Information on Stage Kit TMAP Sensor Modification

TECHNICAL SERVICE BULLETIN

Reference Number(s): 09-06-04-009, Date of Issue: March 02, 2009

Affected Model(s): 2008-2009 HHR SS; Equipped with 2.0L Engine (VIN X - RPO LNF)

Fig. 1: View Of Duct

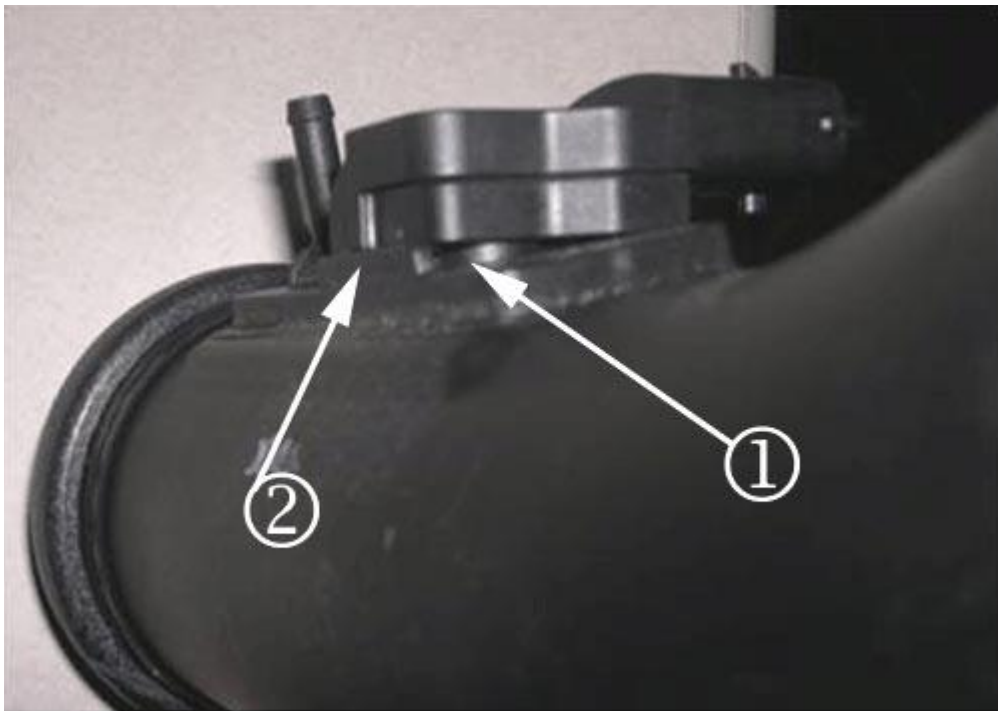
Inspect the TMAP sensor when mounted on the charge air duct. Note how the TMAP sensor is not mounted flush on the duct (1).

Fig. 4: View Of Mounted TMAP Sensor

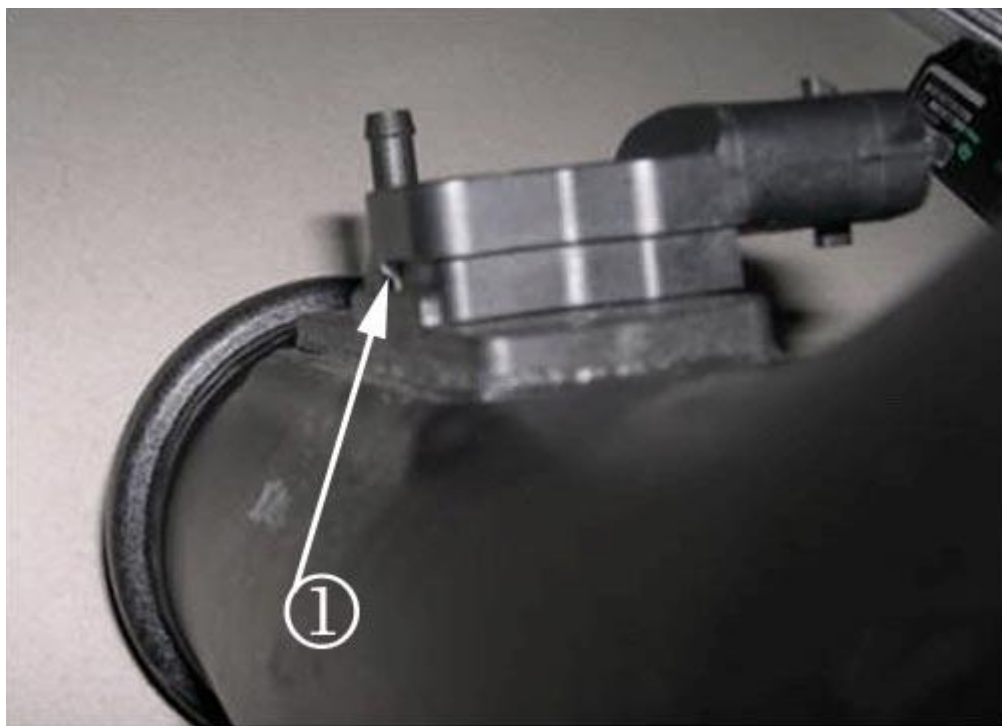
The TMAP sensor mounted flush onto the duct (1).
